Subject: UniStar Nuclear Energy, NRC Docket No. 52-016
Response to Request for Additional Information for the
Calvert Cliffs Nuclear Power Plant, Unit 3,
RAI 321, Fire Protection Program

**RAI No. 311, Question 09.05.01-18,
Fire Protection Program**

Calvert Cliffs Nuclear Power Plant, Unit 3

Question 09.05.01-18

Figure 9.5-2— {CCNPP Unit 3 Fire Water Distribution System – Intake Structure Loop}

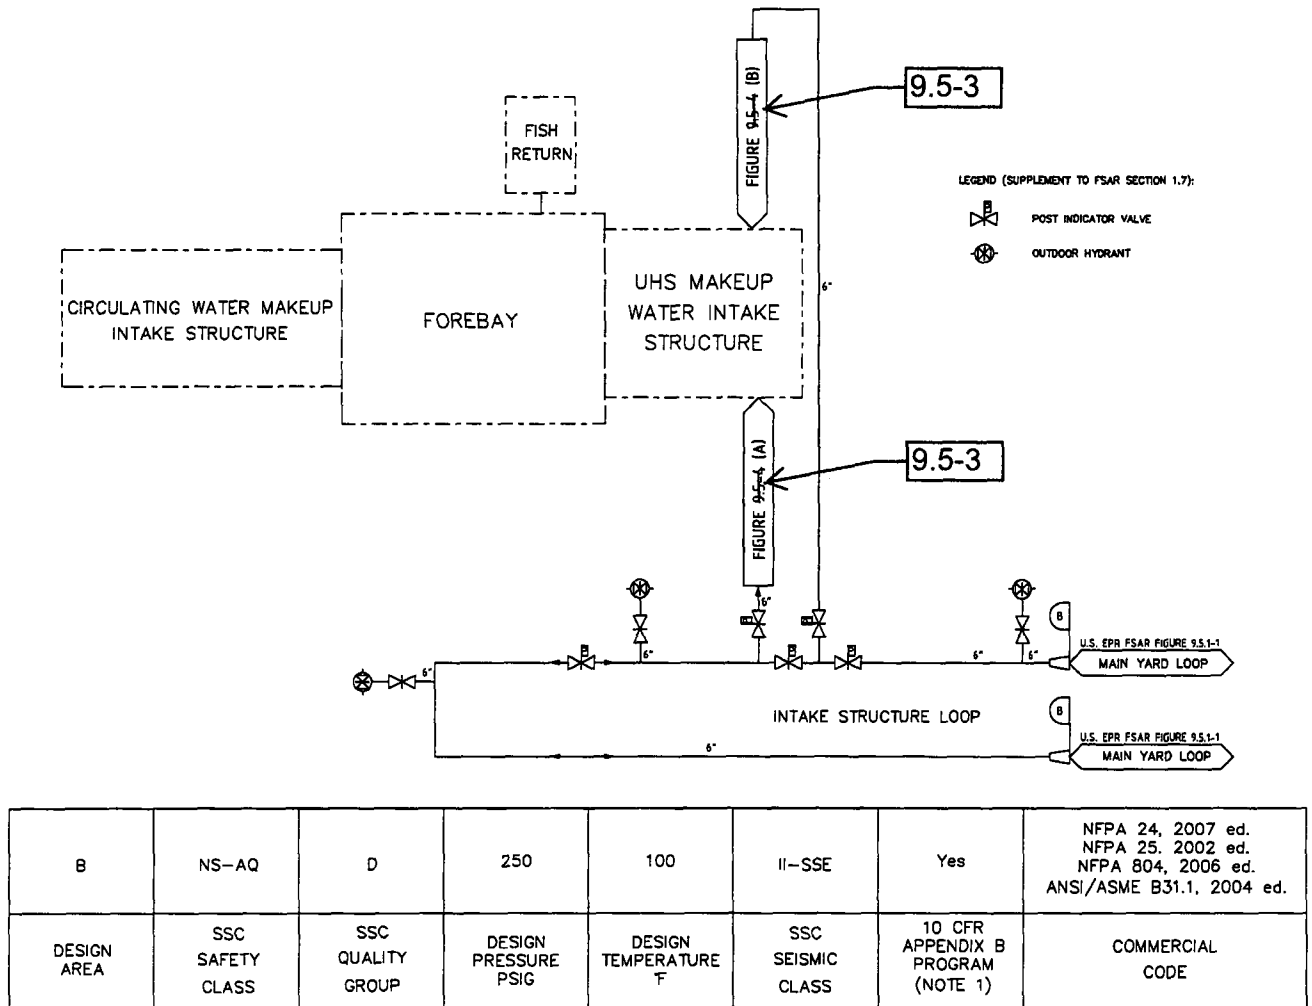
Section 9.5.1.2.1 addresses COL Information Item 9.5-19 which relates to providing site-specific Fire Protection System piping and instrumentation diagrams. The applicant in this section described providing Figures 9.5-2 and 9.5-3 to address this issue. CCNPP Unit 3 FSAR Revision 6 had these figures as per Section 9.5.1.2.1. CCNPP Unit 3 FSAR Revision 7 revised Figures 9.5-1, 9.5-2, and 9.5-3 such that the write-up in Section 9.5.1.2.1 no longer applies to the revised figures. Update Section 9.5.1.2.1 to agree with CCNPP Unit 3 FSAR Revision 7 revised Figures 9.5-1, 9.5-2, and 9.5-3.

FSAR Section 9.5.1.2.1 will be revised, as identified COLA Impact section below, to agree with CCNPP Unit 3 FSAR Revision 7 revised Figures 9.5-1, 9.5-2, and 9.5-3. Minor changes will be made to FSAR Figures 9.5-2 and 9.5-3, as identified COLA Impact section below, so that they correctly refer to each other. In addition, one paragraph in FSAR Section 9.5.1.2.1 that was inadvertently duplicated will be deleted.

FSAR Figure 9.5-2 will be revised as follows:
